RECOMMENDED SERVICE BULLETIN

RSB 42-089/1

RSB 42NG-017/1

Replacement of seals in main landing gear damper.
ATA-Code: 32-10

Picture 4

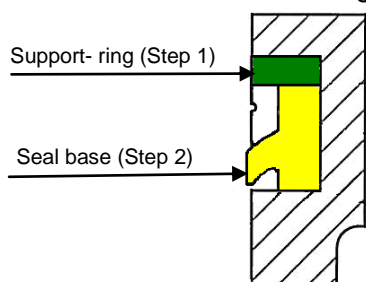
Install the support ring. Deform the ring carefully acc. to picture 4.

CAUTION Avoid excessive bending of the support ring.

Picture 5

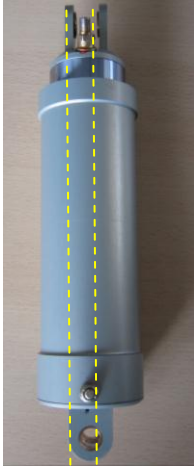
Install the seal base below the support ring:

Deform the seal base acc. to picture 5 and install it in the cylinder tube.
Press the seal base into the groove.

Drawing Number:
D60-3277-10-00_01

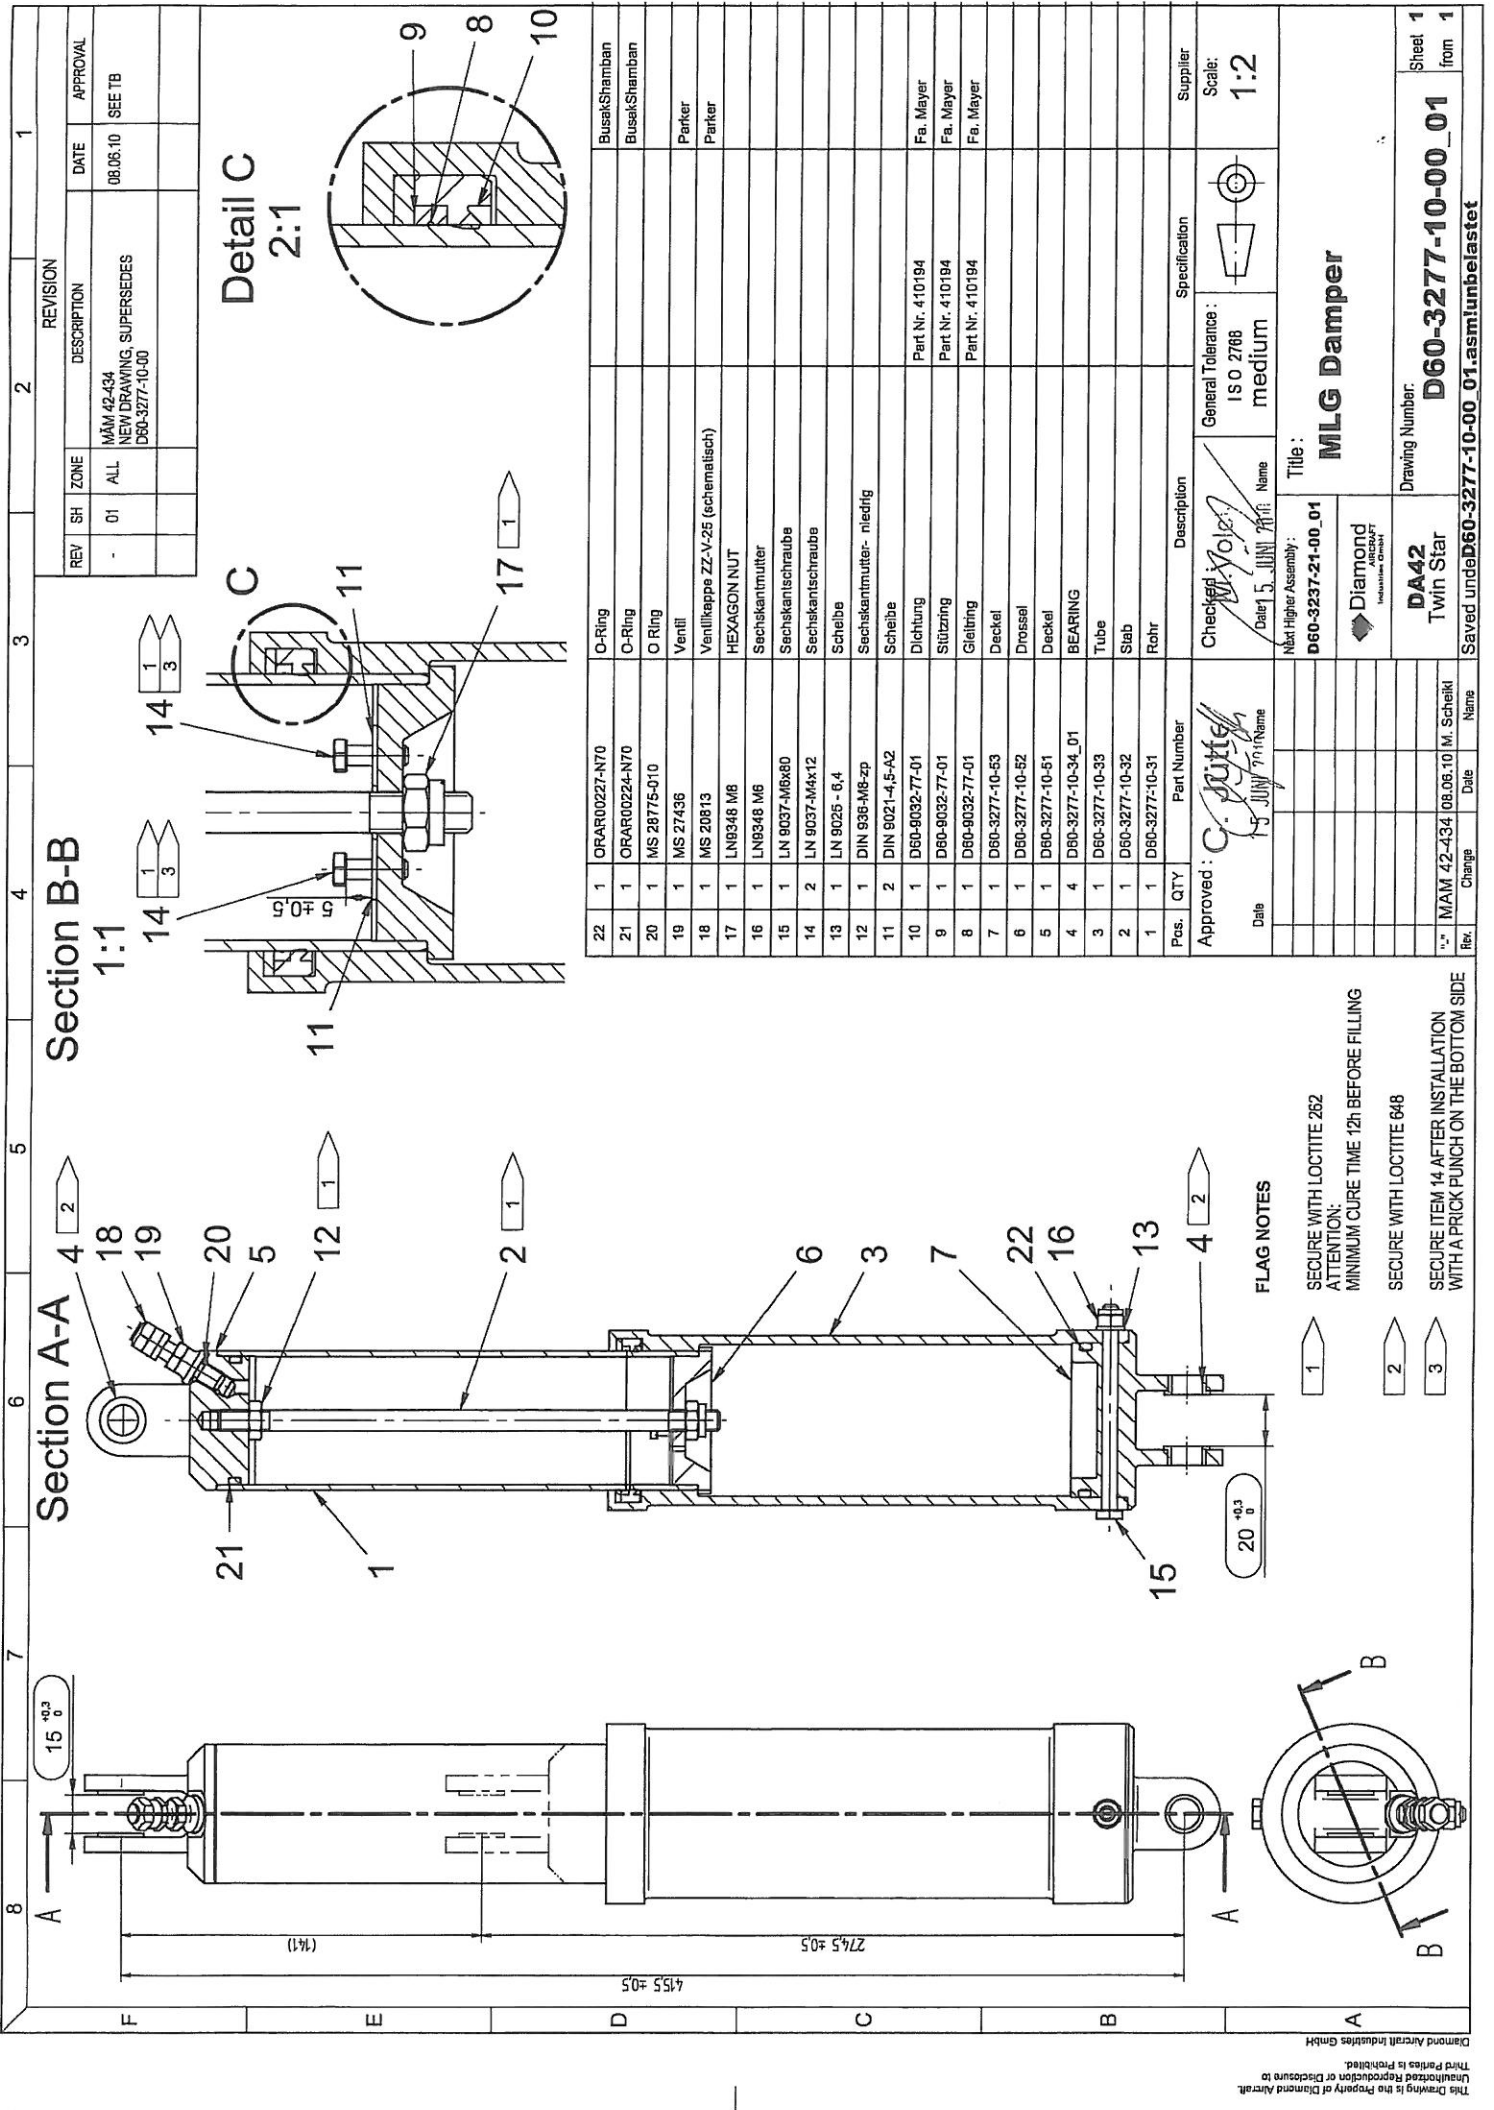
REV	SH	ZONE	DESCRIPTION	DATE	APPROVAL
-	01	ALL	MAM 42-434 NEW DRAWING, SUPERSEDES D60-3277-10-00	08.06.10	SEE TB

- 1 SECURE WITH LOCTITE 262
ATTENTION:
MINIMUM CURE TIME 12h BEFORE FILLING
- 2 SECURE WITH LOCTITE 648
- 3 SECURE ITEM 14 AFTER INSTALLATION
WITH A PRICK PUNCH ON THE BOTTOM SIDE
